Addendum

Solicitation Name	Alterations at Guy B. Love Towers C20013	Addendum Number	4	Date	12/02/19
--------------------------	--	------------------------	---	-------------	----------

ADDENDUM NUMBER 3 - ELECTRICAL

LOVE TOWERS RENOVATIONS
Knoxville, Tennessee
December 02, 2019

PARTIAL ELECTRICAL RISER DIAGRAM

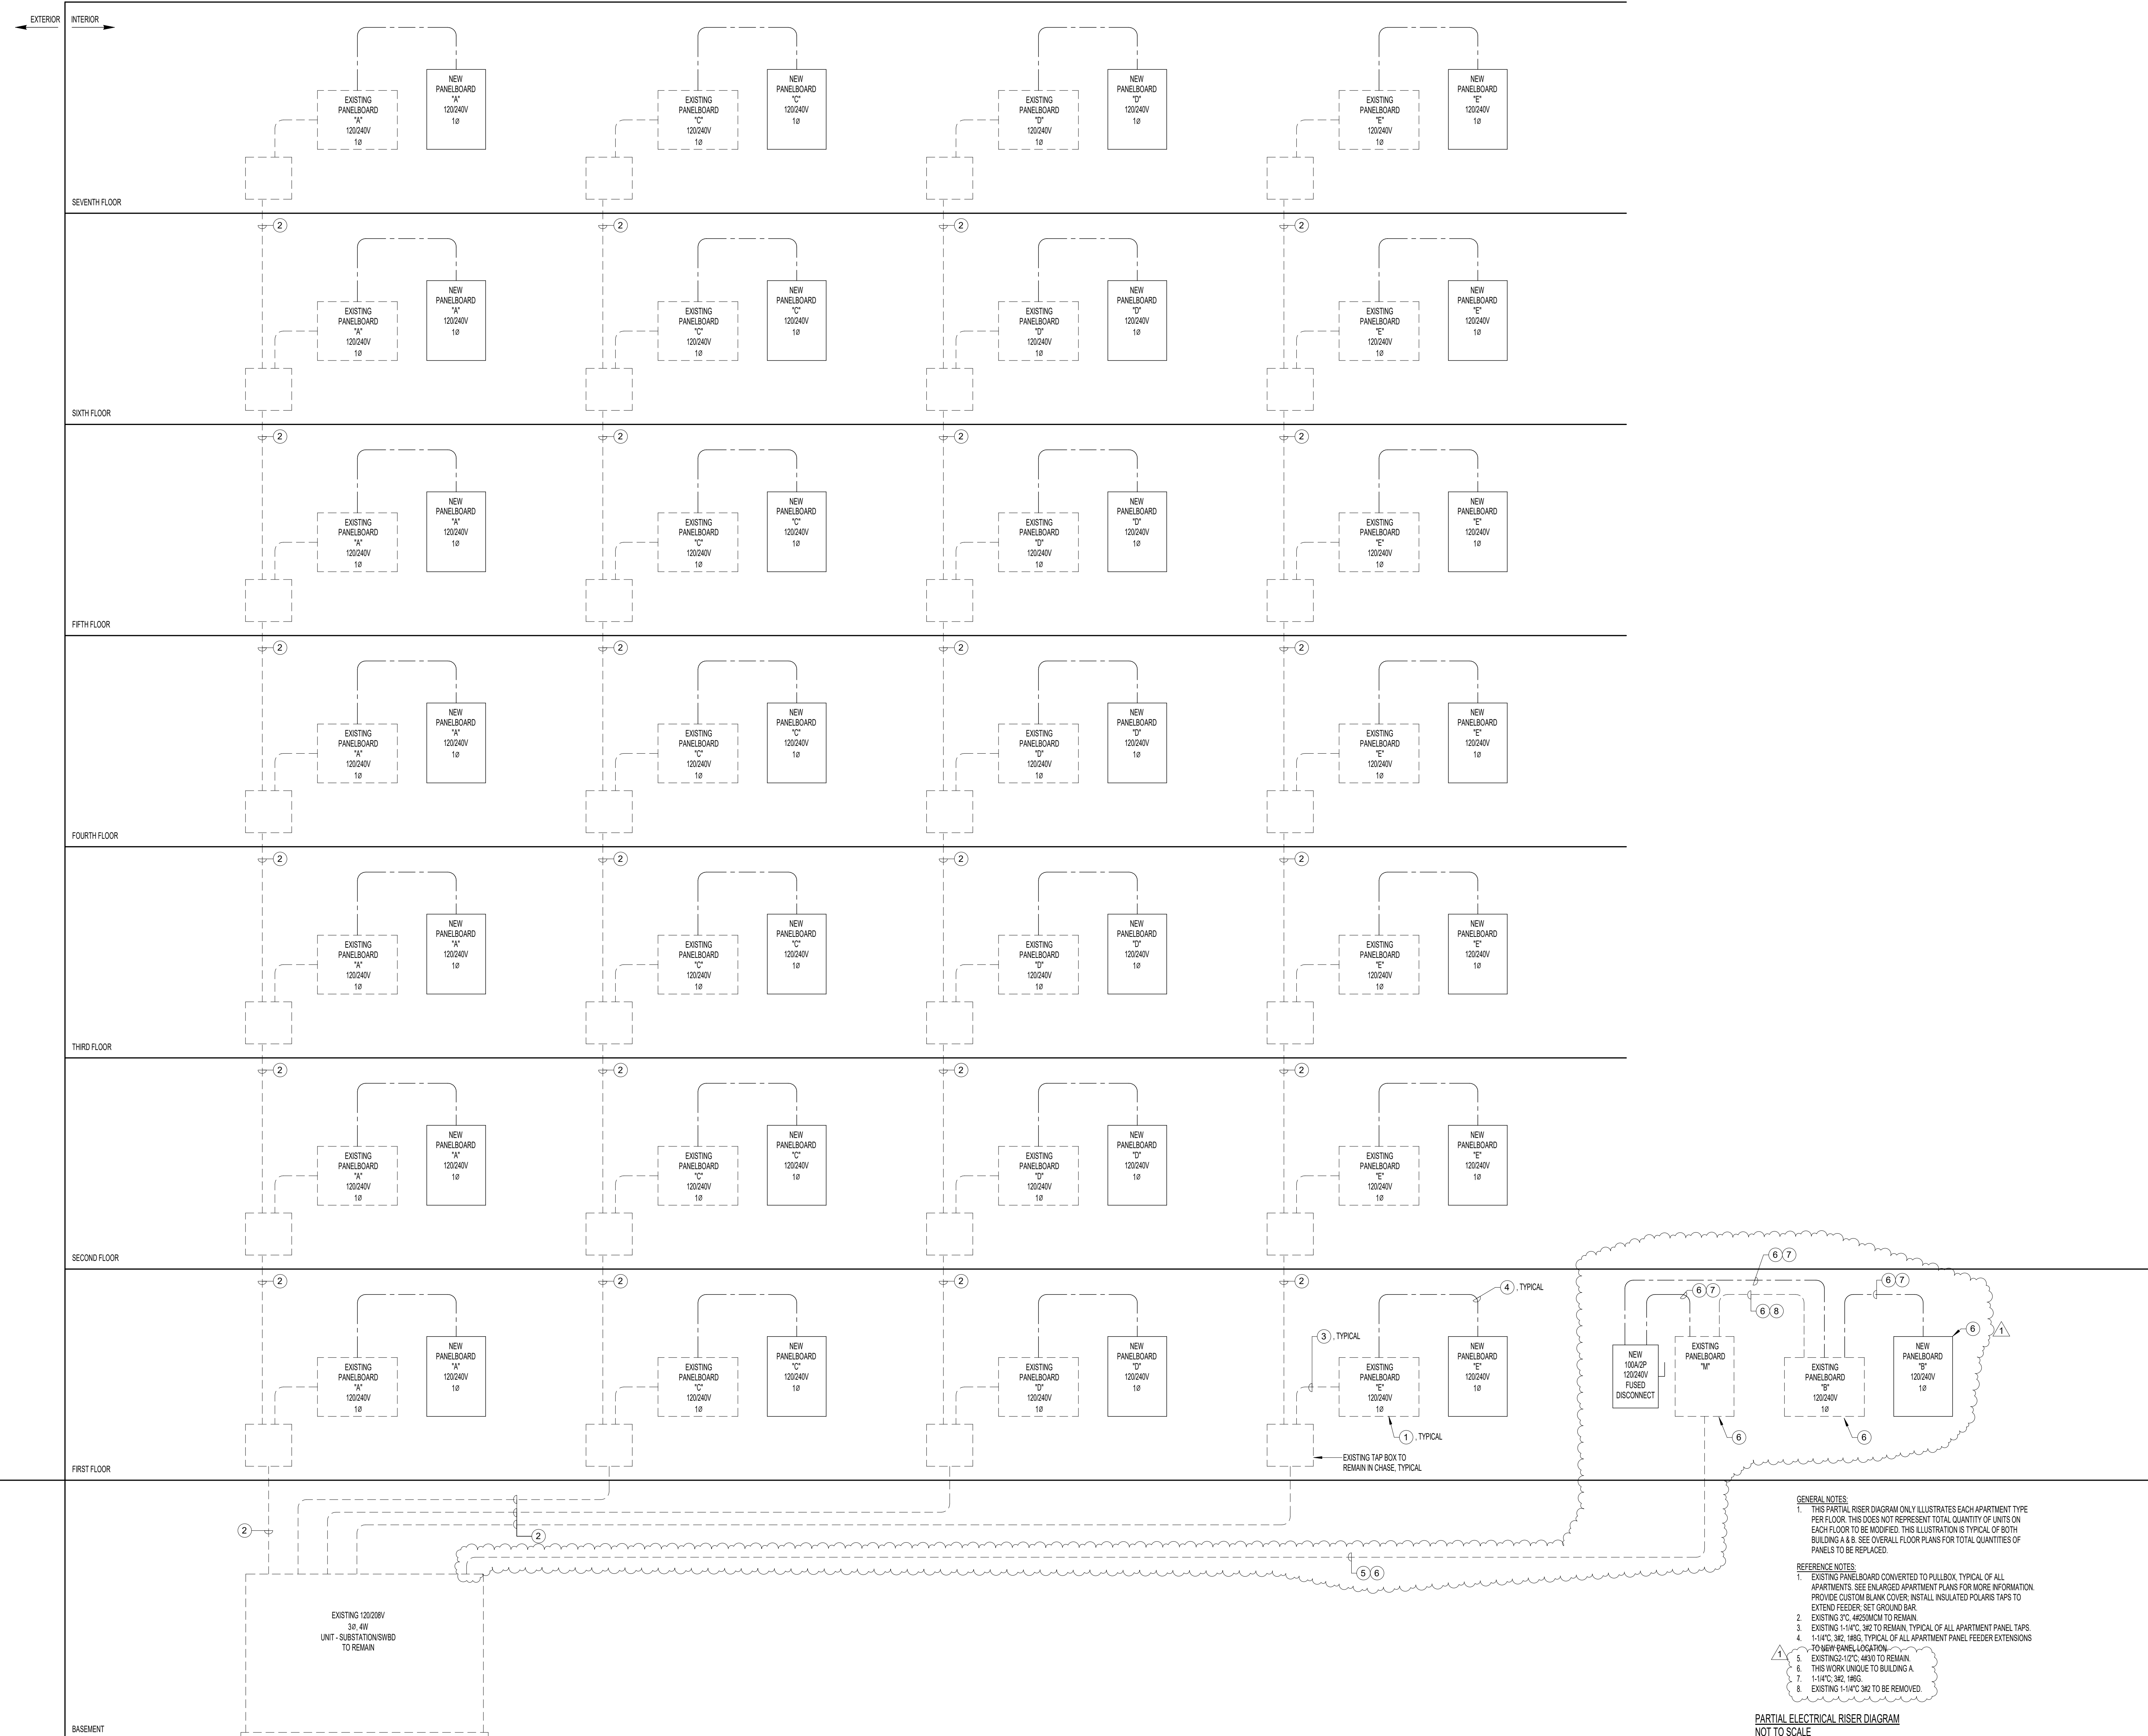
1. Refer to drawing E0.1. Refer to lighting notes. Add the following lighting note: "All exit signs and emergency lighting are existing to remain except where shown on plans."
2. Refer to drawing E0.1 Fire alarm system notes. Add the following note: "Fire alarm wiring to be as follows: MAPNET/IDNET CIRCUIT, COMMUNICATION/DATA LINE – 2#18 TWISTED/SHIELDED, STROBE CIRCUIT, HORN/STROBE CIRCUIT – 2#14, 24 VDC MAPNET/IDNET POWER – 2#14."
3. Refer to drawings E1.0, E1.1, E1.2, E2.0, and E2.1. Add the following general note: "All floors assumed to be 2-hr fire rated concrete."
4. Refer to attached revised drawing E2.1 for additional receptacle in ADA type 0 unit.
5. Refer to attached revised drawings E0.2, E0.3, E1.1, and E2.0 for changes associated with replacement of 3 bedroom unit panelboard in Building A.
